## Responses to editor and reviewers

Thanks very much for taking your time to review this manuscript entitled “The formation processes and development characteristics of boulder bars due to outburst flood triggered by the overtopped landslide dam failure” (Esurf-2020-92). I appreciate all your comments and suggestions! Those comments are constructive for us to revise and improve our paper. We have read these comments carefully and tried our best to revise and improve the manuscript. The revised contents have been highlighted in blue in the revision. The followings are the point-to-point response for each comment. We hope our revision will make the manuscript acceptable for publication. Thanks again!

**Figure.1.** boulder bar obstructs the outburst flow to the river bed lower reaches

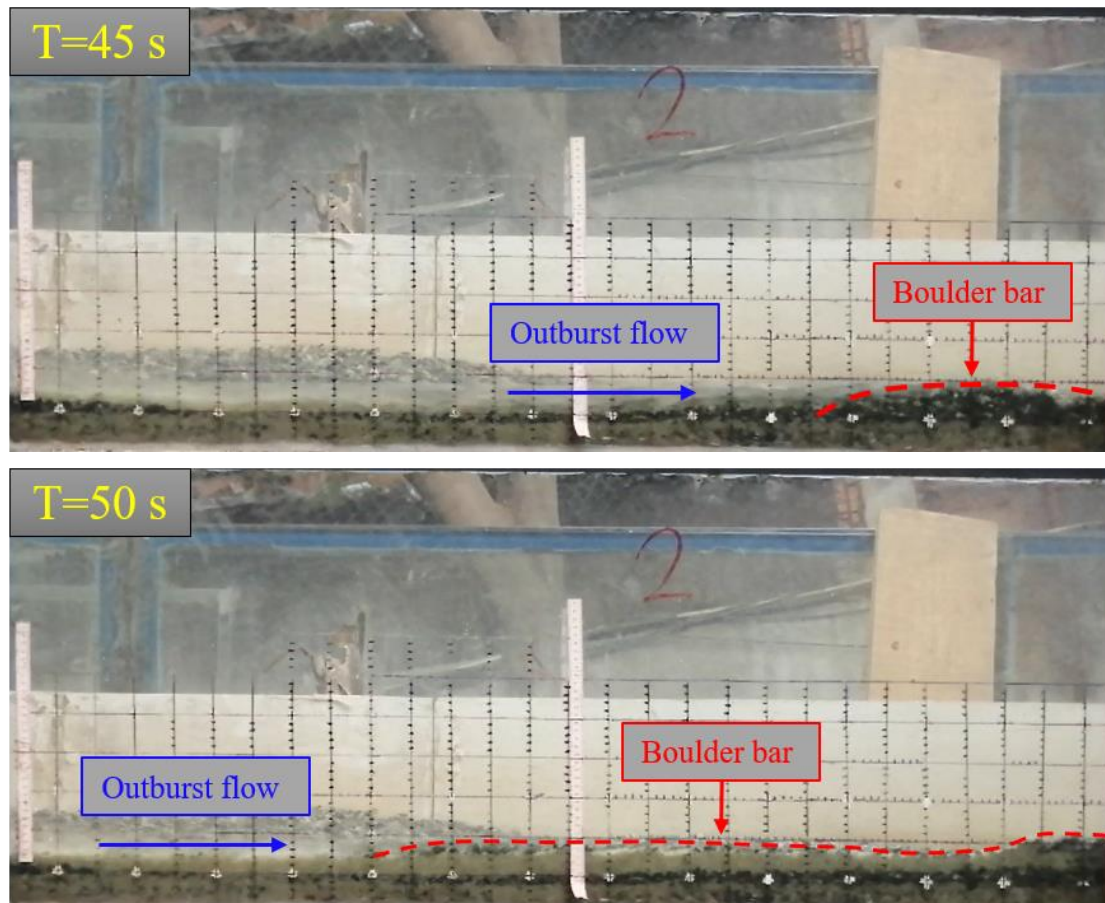
*1. The use of the term 'sandbar' is ill-founded. The experiment does, in fact, use a substrate that is approximately 40 percent sand. However, because of the scale and high Froude conditions ( $>2$ ), the experiment best represents a canyon, gravel bed system. The formative processes of 'sandbars' in this experimental design are entirely different than the sedimentary bodies described in lines 54 to 108 of the Introduction. In that section, there is extensive review of sedimentary bodies that are not genetically nor stratigraphically related to the sandbodies formed in these experiments which, at the scale of the experiment are gravel alternate bars. The fact that the bars in the experiment migrate in the upstream direction is evidence that the experiments are simulating Froude-supercritical (diffusive) conditions (Shaw and McElroy, 2016), whereas most of the sandbars described in the Introduction (except those formed by landslide dams) are formed by translative depositional processes. I would suggest the authors re-visit the process scaling of the experiments to re-frame and strengthen the experimental justification and basis, and the scientific contributions of the results. Kleinhans et al. (2014) and Shaw and McElroy (2016) provide excellent discussions on linkages between sedimentary processes in flumes and those in rivers.*

In addition, we agree the reviewer's opinion that the boulder bar in the experiment is indeed formed by the diffusion rather than translation of bedload. And we also found this phenomenon in the experiment. As shown in Figure 1, when the discharge is reduced, some gravels will stay on the river bed and hinder the advancement of the upstream flow, and part of the sediment in the flow will be deposited. As time goes by, the accumulation of sediment on the side of the boulder bar increases, and the boulder bar appears to develop upstream. We have added the explanations as the reviewer's suggestion to the 3<sup>rd</sup> paragraph of *Introduction* section and the last paragraph of section 3.1.

**Figure.9.** Google field images of four cases

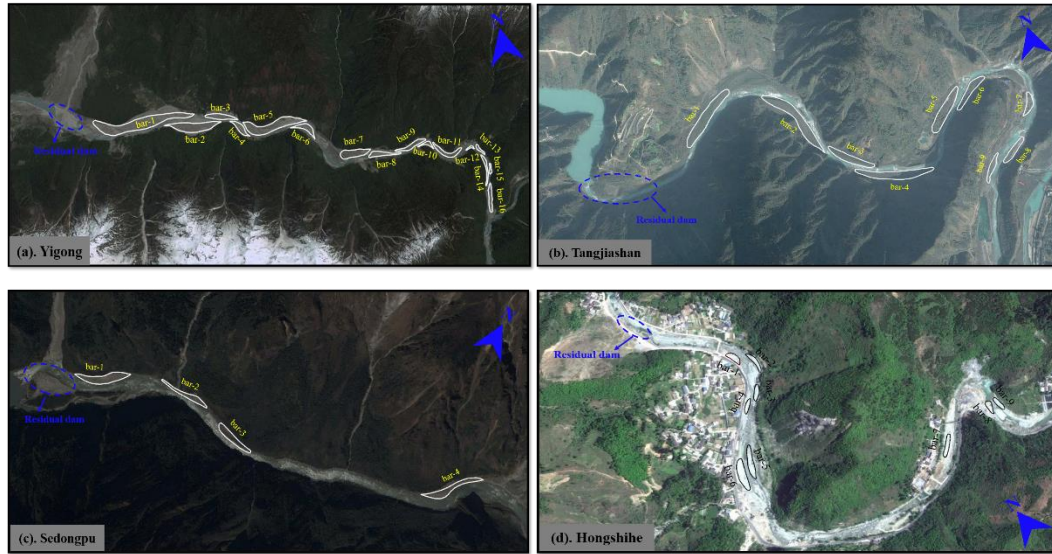
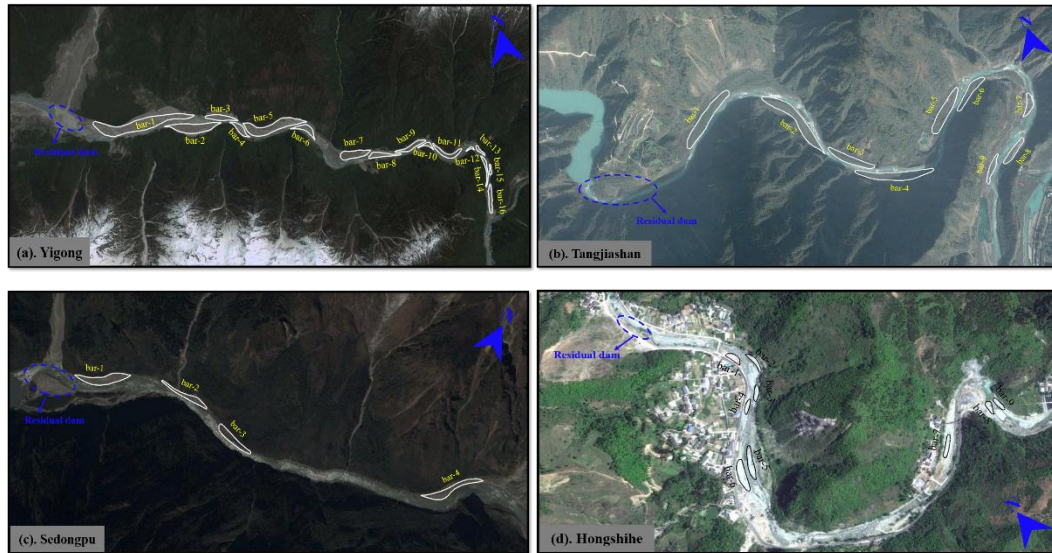
*• Discussion: The discussion is somewhat approved from the previous version; however, the Discussion needs substantial improvement in order to put these results in a larger scientific context. First, the Discussion should start with referring back to the scientific objective stated in the Introduction (see previous point) in order to summarize the results for the reader and explain how the scientific objective was met (or answers hypotheses). Then you should explain how your results are supported (or not) by other studies. Currently, the Discussion only references two other studies,*

*which is not sufficient to put this study in a larger context of boulder bars or channel morphology downstream of outburst floods. These cannot be the only two studies examining morphology downstream of outburst floods. This comment relates to the first bullet point that the manuscript is lacking scientific justification and explanation of how this study connects to a wider scientific context of outburst floods, channel morphology and boulder bars, beyond this one case on the Yigong River.*

Thanks for your suggestion. We collected four field cases, which are Yigong landslide dam, Tangjiashan landslide dam, Sedongpu landslide dam, and Hongshihe landslide dam. We investigated the geometric size and distribution of 38 boulder bars in the field. And compared them with the boulder bars formed in the experiment. The results show that the experimental results are consistent. We have added the related contents in *Discussion* section.

**Figure.8.** Geometry characteristics of boulder bars after the dam failed in the experiments. (a)

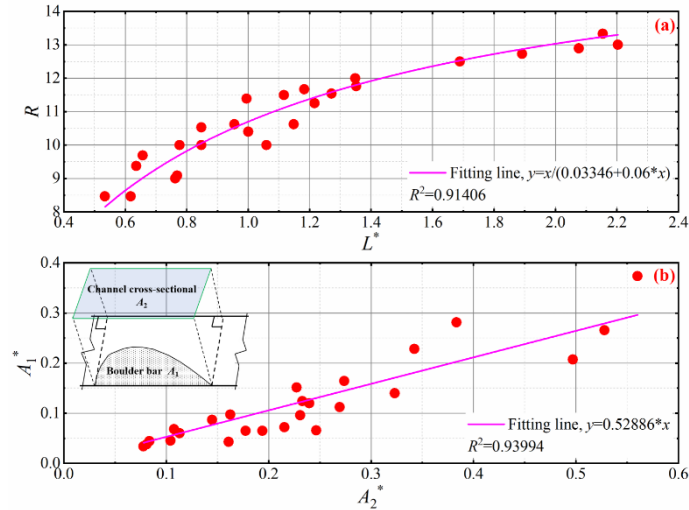
*Section 4: It is confusing that sediment concentration is calculated using a reference to Laursen, with no reference to how this was done or whether we are talking about bed load or suspended load. For true sandbars, it seems that the suspended sediment component would dominate. Later in this section, the MPM formula is used for bed*

*load transport capacity, but how is  $u^*$  defined given the supercritical flow conditions.*

*I don't know if it is appropriate to use MPM without consideration of the effect of Froude number on the energy slope; this may lead to spurious negative correlations between Froude number and transport capacity.*

Thanks a lot for the reviewer's comments. It is difficult to measure the concentration and sediment carrying capacity of outburst flow exactly and timely during experimental process. So, we adopted the calculated methods to obtain the concentration and sediment carrying capacity values in the first version manuscript. However, the content of section 4 in the original manuscript may cause confusion to the readers. Therefore, we decided to delete the content of section 4 in the original manuscript. And we added the contents about geometry characteristics of the boulder bars in section 4 in the revised draft as follows:

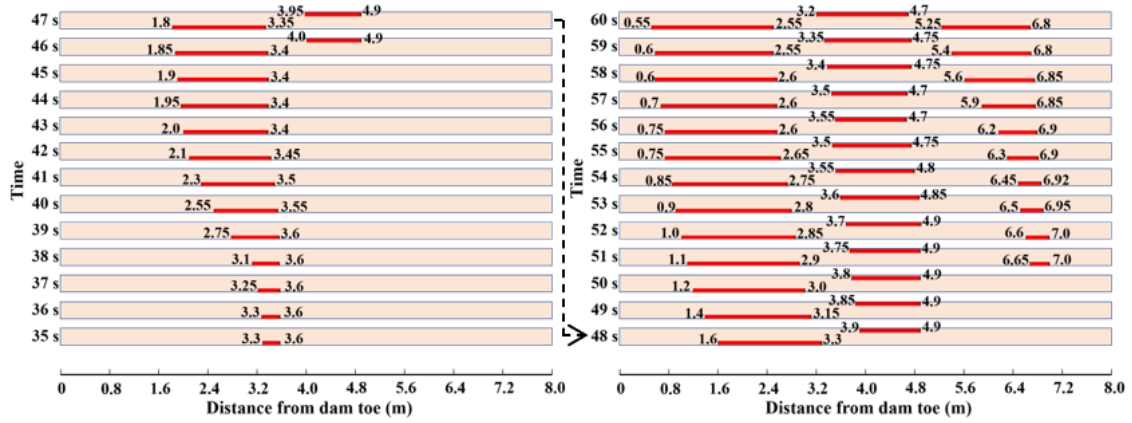
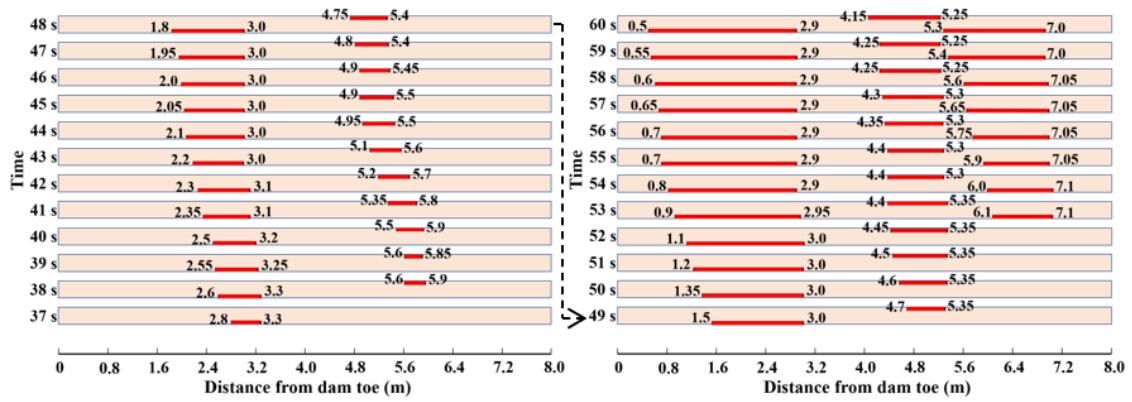
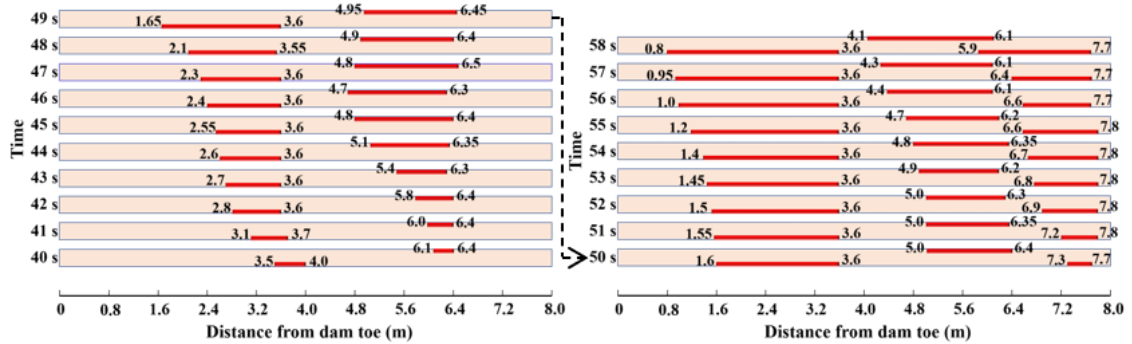
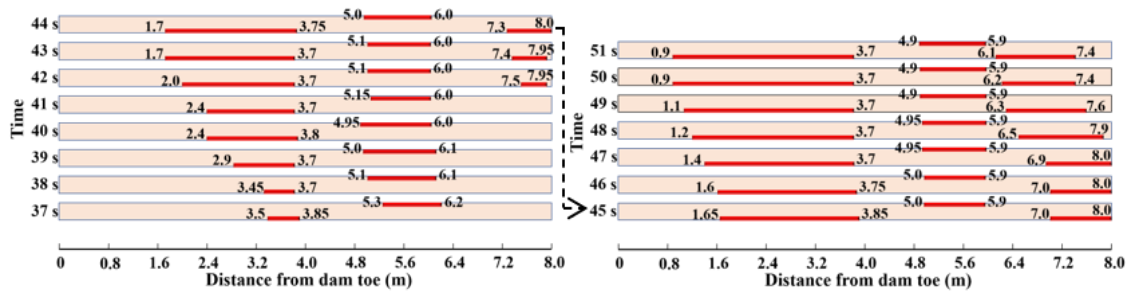
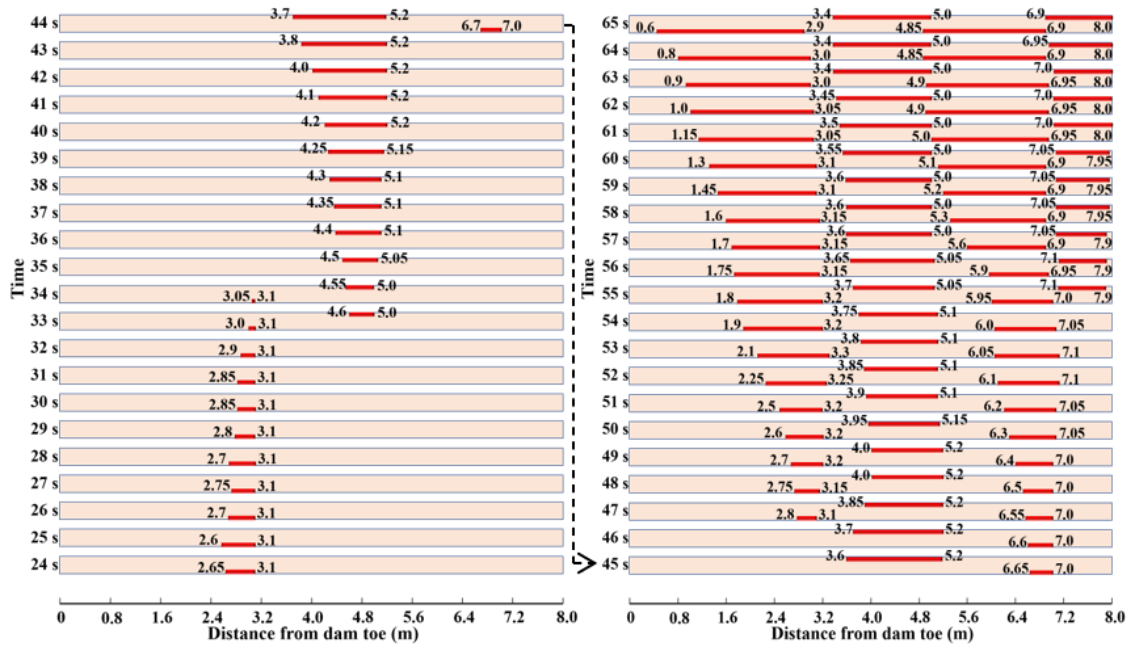
*Figure 4: I wonder if this figure could be simplified to focus on the key points in the discussion of the figure that describe the 3 variations of response*

Thanks a lot for the reviewer's comment. Figure 4 in the manuscript shows the change of the position of the boulder bar during the dam failure process. Figure 4 can very intuitively and vividly express the change of the position of the boulder bar over time. Therefore, if possible, we would like to retain the contents of Figure 4. But the format of the figure has been changed as follows:

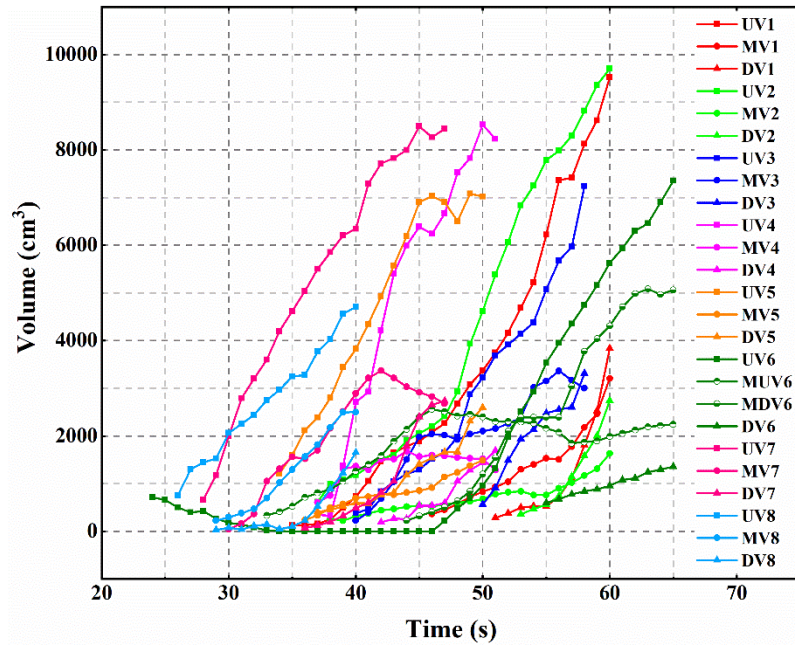
*Figure 6: Same comment as figure 5 with regard*

Thanks a lot for the reviewer's comment. This suggestion is very helpful to us. We have modified Figure 6 in the manuscript as suggested by the reviewer, as shown below:
